TB10047

Topic: MIX font button upgrade		TB No.: 10047	Date: 21/03/2018
Affected Machines:	MIX Font, 1 button (P/N 1000878) & 3 button (P/N 1000879)	Priority: Low	Created By: Gareth Fitzpatrick
From Serial No.:	>0817xxxx <0218xxxx	Reason:	Part update
From Date:	Aug 2017 to Feb 2018	Pages:	1/2

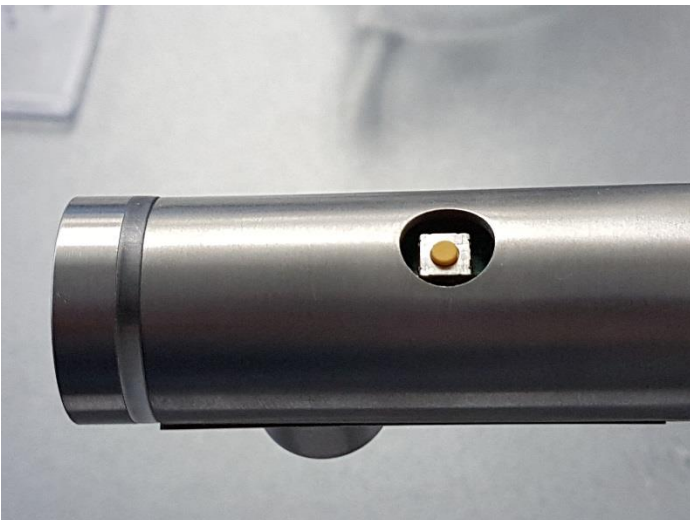
It has come to our attention that a small batch of MIX font button material of the following serial range >0817XXXX TO 0218XXXX is defective. The particular batch has a weakened material resulting in premature wear after a short period. The button will deform out of shape. The affected part No of the button is **1860361**.

1. Power down the boiler at the mains power supply before fitting the new button. The font ring light should not be illuminated.
2. Remove the defective button by prising free using a small size screwdriver. **Fig 1 & Fig 2**. Take care not to damage the tactile switch underneath the rubber button. See fig 3.0 to view the PCB and tactile button.
3. Slot the new button into the hole by pressing firmly around the edges until the lip is secure in the hole. **Fig 3 & Fig 4**.
4. For three button models (MIX FONT THREE BUTTON **P/N1000879**) replace all three buttons.
5. Power back on the boiler and test by pressing the button.

New MIX button with improved durability. The improved button has been implemented on all builds commencing 0318XXXX.
